IREDELL COUNTY HEALTH DEPARTMENT

SEPTIC IMPROVEMENT PERMIT / AUTHORIZATION TO CONSTRUCT / OPERATION PERMIT / EXISTING SYSTEM

SUBDIVISION: Twin Creek Estates SECTION: 1 LOT # 12 LOT AREA: .76 ac DESIGN FLOW: 480 gpd L.T.A.R.: .35

Proposed Design for a 25% Reduction Septic System using Gravity distribution for a 4 bedroom single family residence on Lot 12 of Twin Creek Estates Subdivision Phase 1, 162 Rushing Water Ln. in Troutman, Iredell County, North Carolina.

AS BUILT SKETCH

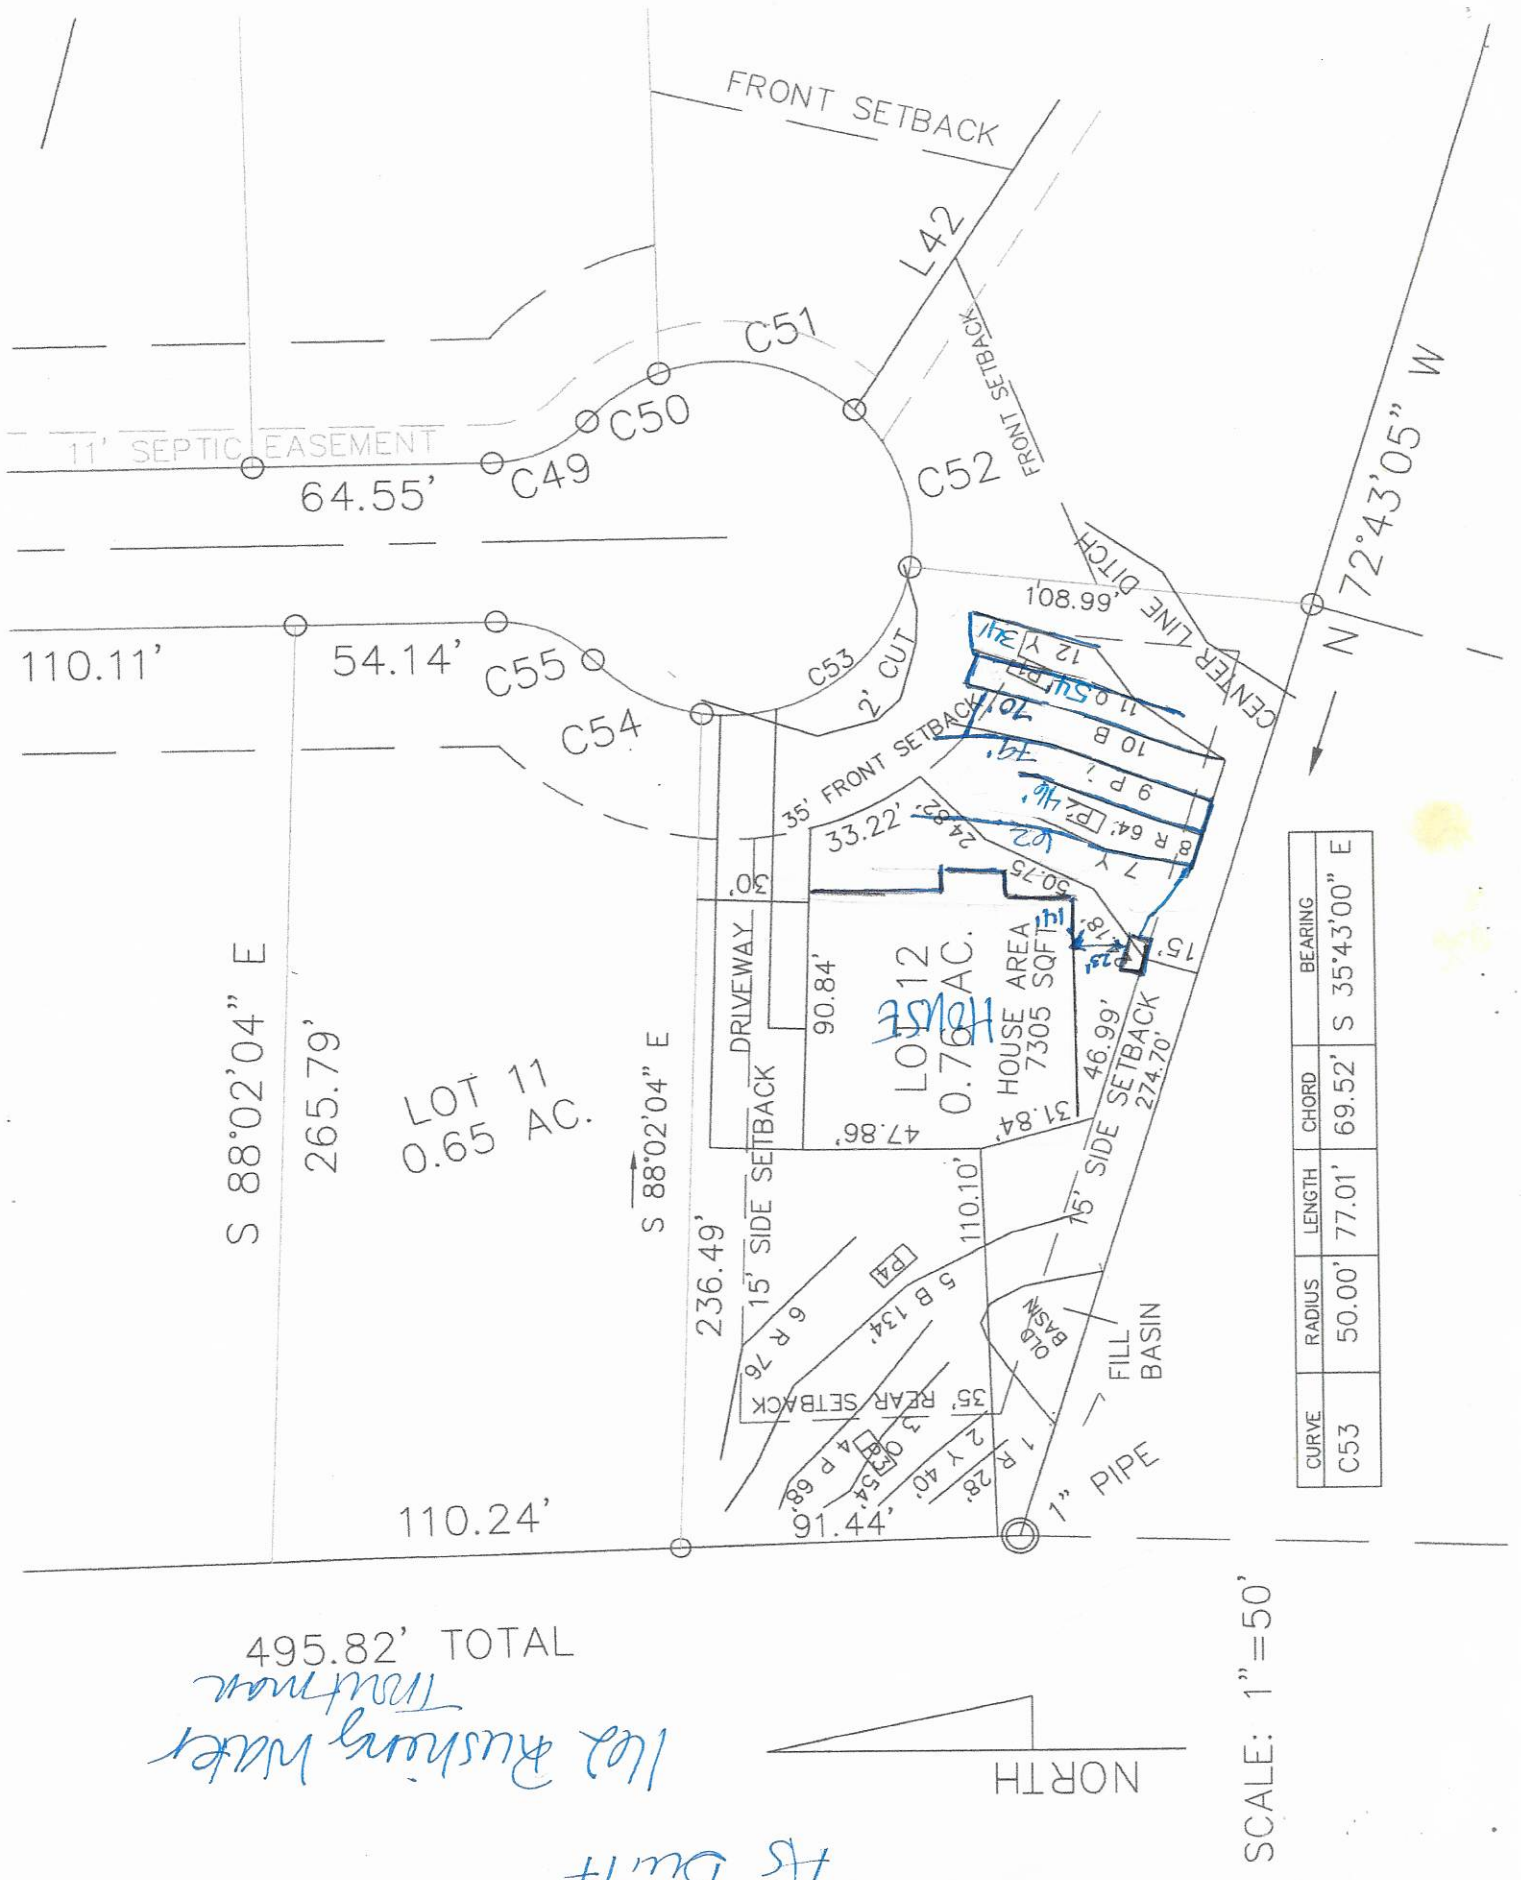
TO Get OP, following items needed:

(1) Left property line needs to be marked & location of drain lines verified - 10ft setback

(2) Drain pipe removed from drain field. - Removed 10/7

(3) Basin in backyard filled - Basin no longer considered Basin one side considered
